Subject: MHI's Responses to US-APWR DCD RAI No.773-5646 (SRP 19)

MHI's Responses to US-APWR DCD RAI No.773-5646

US-APWR Design Certification

RAI NO.: 773-5646 REVISION 2

IDCD_19-535

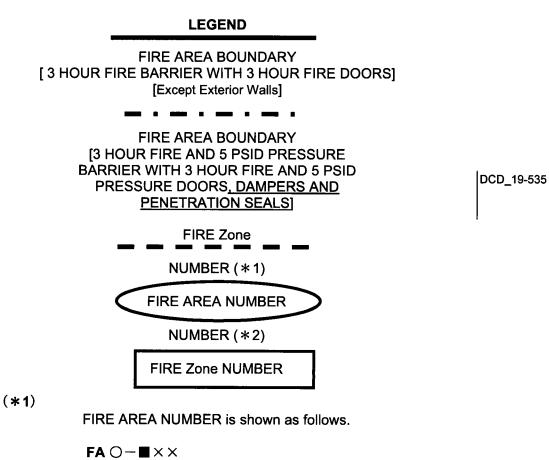
In DCD Section 19A.4.3, the applicant credits the use of 3-hour fire barriers, including fire door and watertight fire doors for separating the safety divisions within the Reactor Building (R/B) and the east and west Power Source Buildings (PS/Bs). Please clarify that all intervening penetration seals and dampers also have 3-hour ratings. Please also clarify that all elements (i.e., wall, doors, dampers, penetration seals) of fire barriers that are key design features and are credited for the "one-barrier" option in NEI 07-13, have both a 3-hour fire rating and are able to withstand 5psid overpressure to prevent fire spread. The US-APWR DCD should identify and describe the specific fire barriers credited for the "one-barrier" option.

"Certain 3-hour fire barriers are protected to a 5 psid pressure requirement. This differential pressure criterion is based on the results of the aircraft impact analysis provided in Appendix 19A and applies to fire rated doors, dampers and fire barrier penetrations seals. The fire barriers with 5 psid requirements are identified in Figures 19A-1 through 19A-12."

Openings and penetrations through fire barriers are protected in accordance with features providing a fire resistance rating compatible with the fire barrier, rating and proven by appropriate independent laboratory testing (i.e., providing 3-hours fire resistance rating). Certain 3-hour fire barriers are protected to a 5psid pressure requirement. This differential pressure criterion is based on the results of the aircraft impact analysis provided in Appendix 19A and applies to fire rated doors, dampers and fire barrier penetrations seals. The fire barriers with 5psid requirements are identified in Figures 19A-1 through 19A-12.
